# Access Compliance Report

## Public Rights-of-Way

Intersection ID: 43083	Main Street: N_KINGS_DR	Cross Street: ARMORY_DR	Location: SE
ADA ID: 216D9314E01B	Ramp Type: Perp	Initial Pass/Fail: Fail	Overall Compliance: No
Severity Score: 22.5			
Codes/Mitigation Info/Possible Solution		Field Measurements/Component Compliance

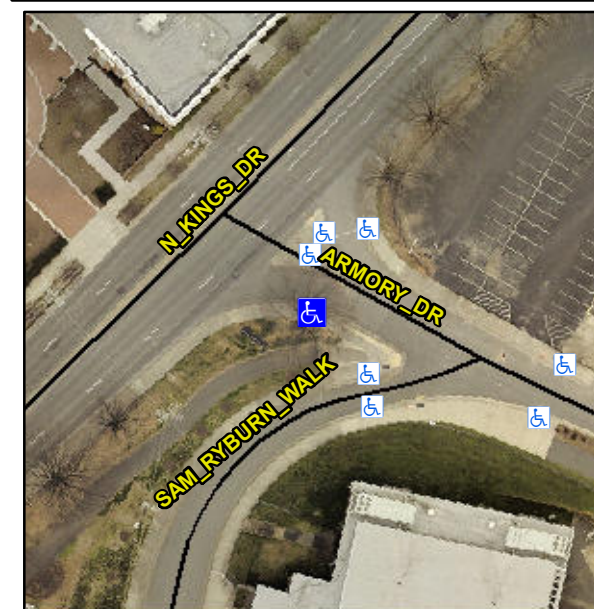
**Not Found, R304.5.1, R304.2.2, R304.5.3**

Compliance	Description	Data	Compliance	Description	Data
N/A	Ramp Length (in)	50.0	No	Ramp Slope (%)	9.7
No	Ramp Width (in)	41.0	No	Ramp XSlope (%)	2.3
N/A	Flare Type LT	N/A	N/A	Flare Type RT	N/A
N/A	Flare Slope LT (%)	N/A	N/A	Flare Slope RT (%)	N/A
N/A	Flare Traversable LT?	N/A	N/A	Flare Traversable RT?	N/A
N/A	Landing Length (in)	N/A	N/A	DWS Provided?	N/A
N/A	Landing Width (in)	N/A	N/A	DWS Contrast?	N/A
N/A	Landing Slope (%)	N/A	N/A	DWS Length (in)	N/A
N/A	Landing X Slope (%)	N/A	N/A	DWS Full Width?	N/A
N/A	Landing Curb? (Y/N)	N/A	N/A	DWS Offset (in)	N/A
N/A	Shared Landing?	N/A			
N/A	Gutter Ponding?	N/A	N/A	Gutter Slope (%)	N/A
N/A	Gutter Lip Ht (in)	2.0	N/A	Gutter X Slope (%)	N/A
N/A	Painted X Walk1?	No	N/A	Painted X Walk2?	N/A
	X Walk 1 Direction	To N		X Walk 2 Direction	N/A
N/A	X Walk 1 Width (in)	N/A	N/A	X Walk 2 Width (in)	N/A
	X Walk 1 Slope (%)	5.0		X Walk 2 Slope (%)	N/A
	X Walk 1 X Slope (%)	0.3		X Walk 2 X Slope (%)	N/A

**Remove & Replace Entire Ramp.**
